Intersection ID: N/A	Main Street: MONROE_RD	Cross Street: BRAMLET_RD	Location:	NW
ADA ID: 4AD8F6E3C497	Ramp Type: PerpDiag	Initial Pass/Fail: Fail	Overall Compliance: No	Severity Score: 21.25

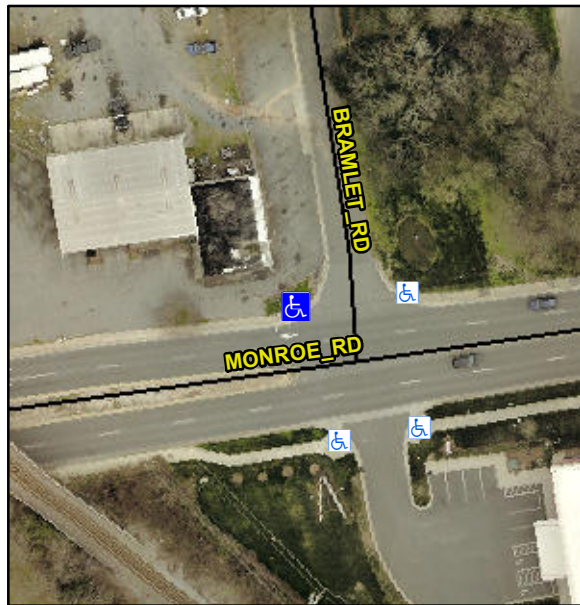
Not Found, R304.5.1, R304.5.3

Compliance	Description	Data	Compliance	Description	Data
N/A	Ramp Length (in)	56.0	Yes	Ramp Slope (%)	6.4
No	Ramp Width (in)	40.0	No	Ramp XSlope (%)	5.2
N/A	Flare Type LT	N/A	N/A	Flare Type RT	N/A
N/A	Flare Slope LT (%)	N/A	N/A	Flare Slope RT (%)	N/A
N/A	Flare Traversable LT?	N/A	N/A	Flare Traversable RT?	N/A
N/A	Landing Length (in)	N/A	N/A	DWS Provided?	N/A
N/A	Landing Width (in)	N/A	N/A	DWS Contrast?	N/A
N/A	Landing Slope (%)	N/A	N/A	DWS Length (in)	N/A
N/A	Landing X Slope (%)	N/A	N/A	DWS Full Width?	N/A
N/A	Landing Curb? (Y/N)	N/A	N/A	DWS Offset (in)	N/A
N/A	Shared Landing?	N/A			
N/A	Gutter Ponding?	N/A	N/A	Gutter Slope (%)	N/A
N/A	Gutter Lip Ht (in)	N/A	N/A	Gutter X Slope (%)	N/A
N/A	Painted X Walk1?	No	N/A	Painted X Walk2?	No
	X Walk 1 Direction	To S		X Walk 2 Direction	To E
N/A	X Walk 1 Width (in)	N/A	N/A	X Walk 2 Width (in)	N/A
	X Walk 1 Slope (%)	6.3		X Walk 2 Slope (%)	0.5
	X Walk 1 X Slope (%)	0.6		X Walk 2 X Slope (%)	11.9

Remove & Replace Curb Ramp With Two New Directional Ramps or Equivalent.
